CRACK SHAPE AND SIZE FOR ASME CODE APPLICATIONS

NRC-B&WOG MEETING 5/5//04

TOPICAL REPORT BAW-2308

RESPONSE TO THE RAI

TSE AND PTSE TEST DATA

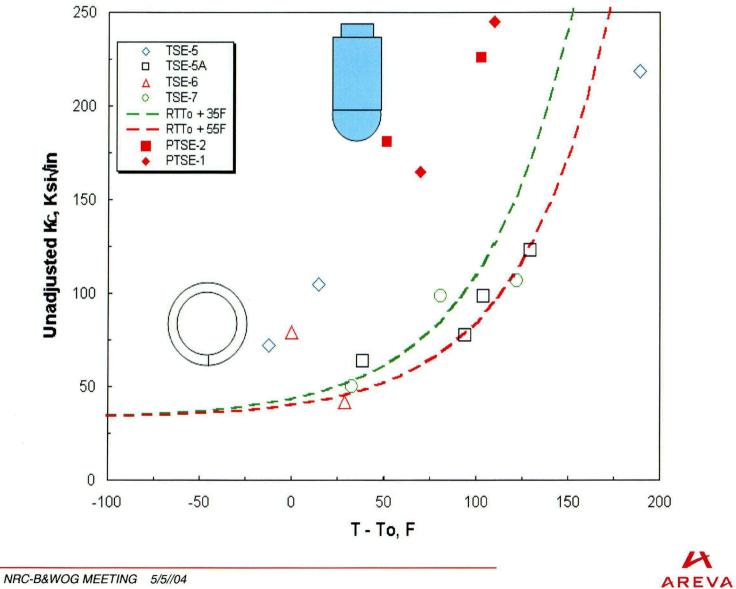
SUMMARY OF TSE DATA PLOT

T₀ BASED ON TSE DATA CONVERTED 1T EQUIVALENT K_{IC}

T₀ USED TO PLOT TSE DATA MAY BE OFF BY CONSIDERABLE AMOUNT DUE TO T₀ VARIABILITY

T₀ Variation Through Thickness

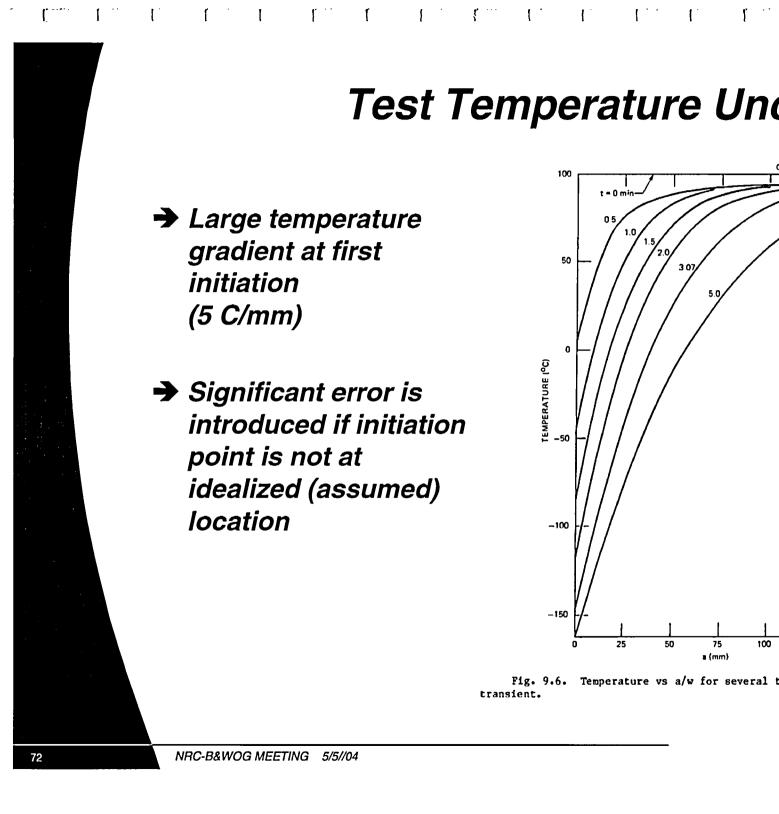
- Over 170 small specimen toughness tests
- Sufficient data to establish through thickness trend
- Atypical reduction of toughness near ID surface

Trend lines represent data trend established in TSP-1 fit to the available data for TSE-5A. Boxed text identifies the location of the TSE crack tip. The likely T0 at that location can then be deduced

Fig. 9.6. Temperature vs a/w for several times during the TSE-5A transient.

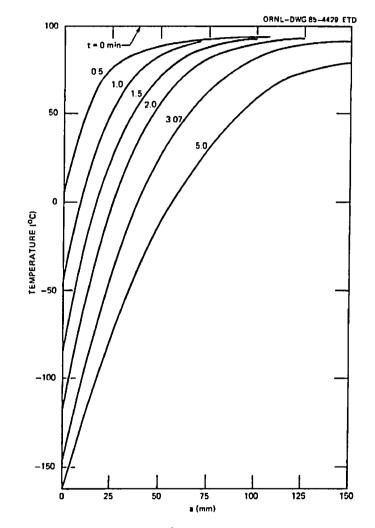
- ➔ Large temperature gradient at first initiation (5 C/mm)
- → Significant error is introduced if initiation point is not at idealized (assumed) location

TSE-7 Initial Flaw

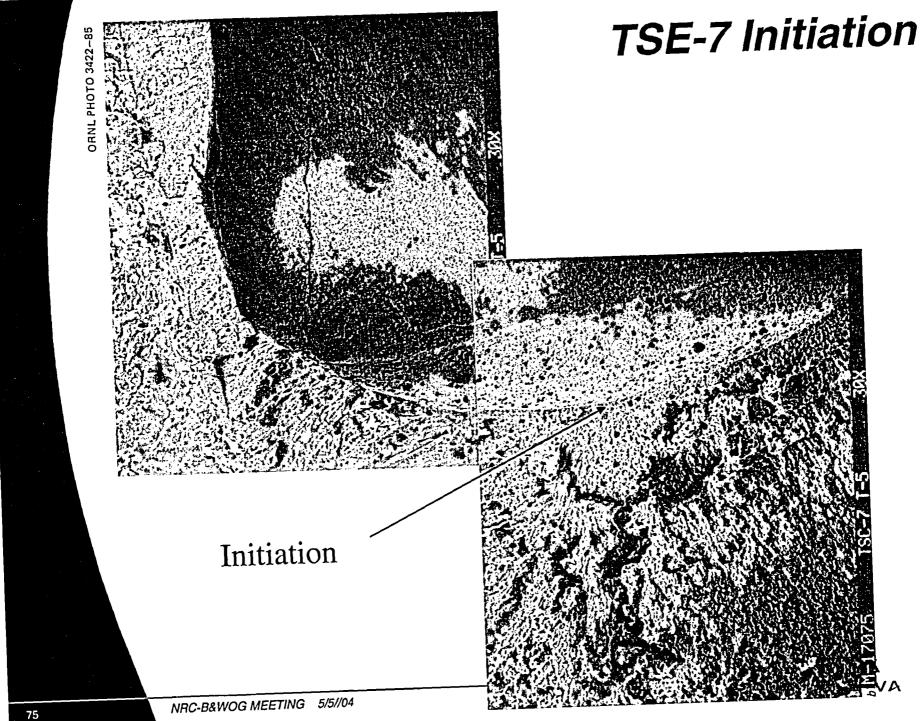
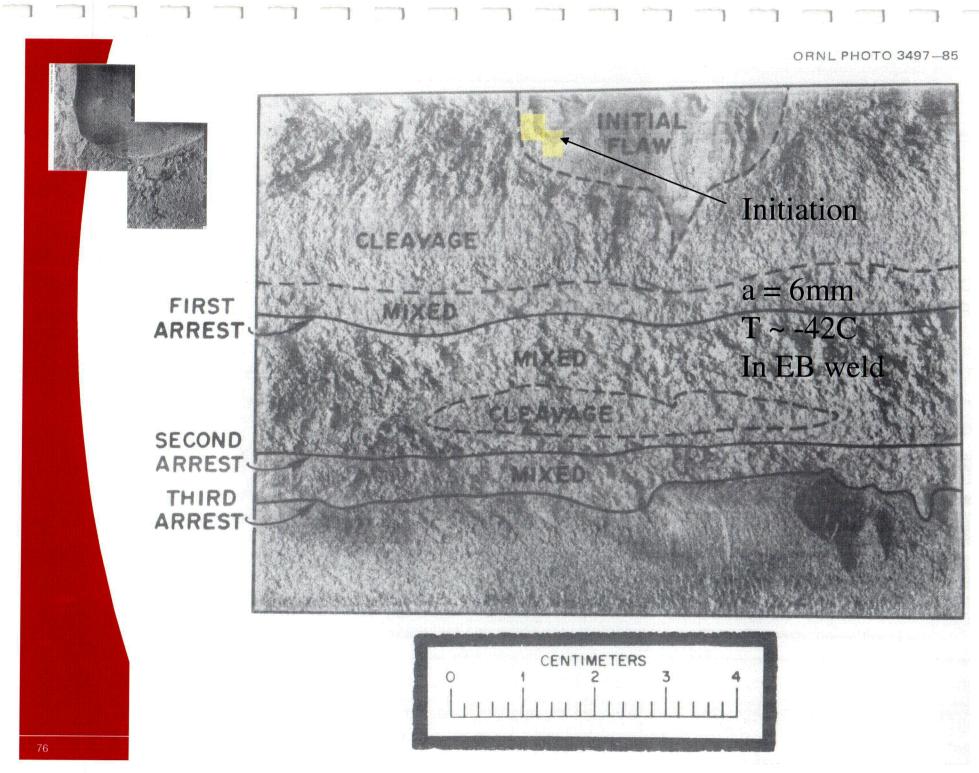
→ Which is it?

Different from idealized semielliptical surface flaw

→ Fig. 8.19.b is misidentified

□ Initiation site of initial crack creation, not first TSE event

➔ Initiation site is at the location shown

□ *Temperature here is ~ -42C, not -19C*

□ Recrystalized EB weld or HAZ material

T. Mager showed that cracks initiating in EB weld have ~ 50% lower toughness (WCAP-7579)

Fig. 8.11. Fracture surface (near midlength of test cylinder) of TSE-5 final long axial flaw.

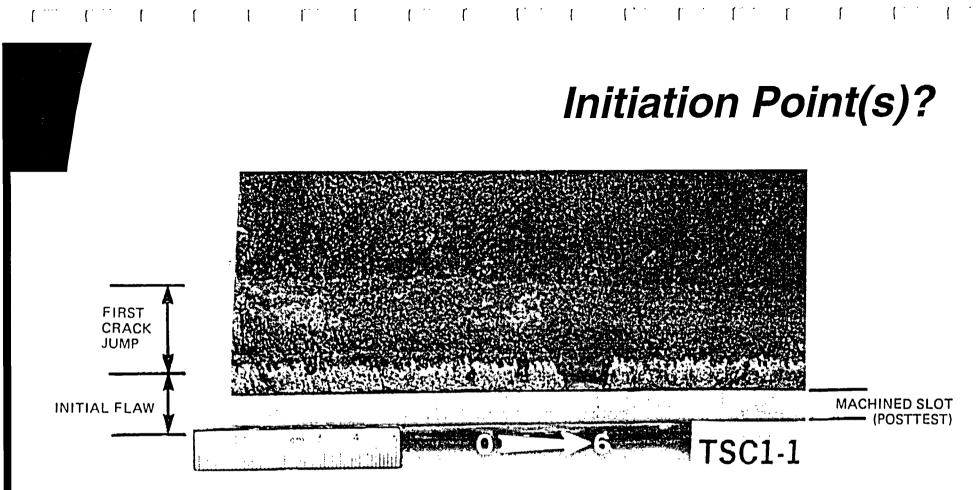
>No attempt was made (that was reported) to verify entire initial crack was in base metal >At what depth is actual initiation site?

Unbroken Ligaments

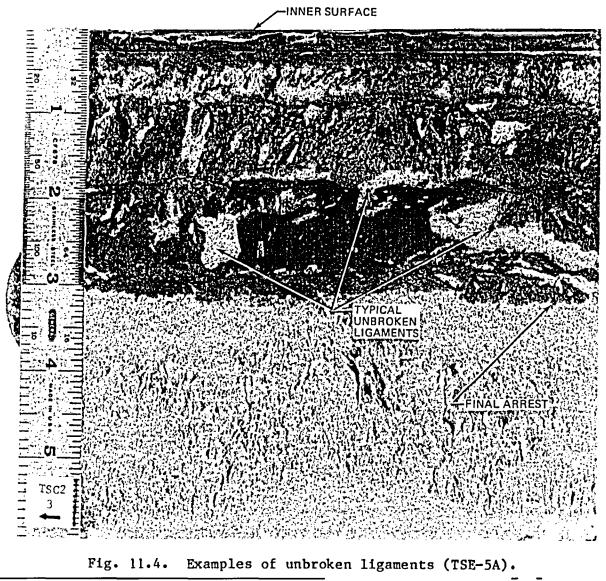
What is the effect of unbroken ligaments on initiation and arrest events?

The K_I seen would not be the same as calculated for idealized 2D or 3D flaw.
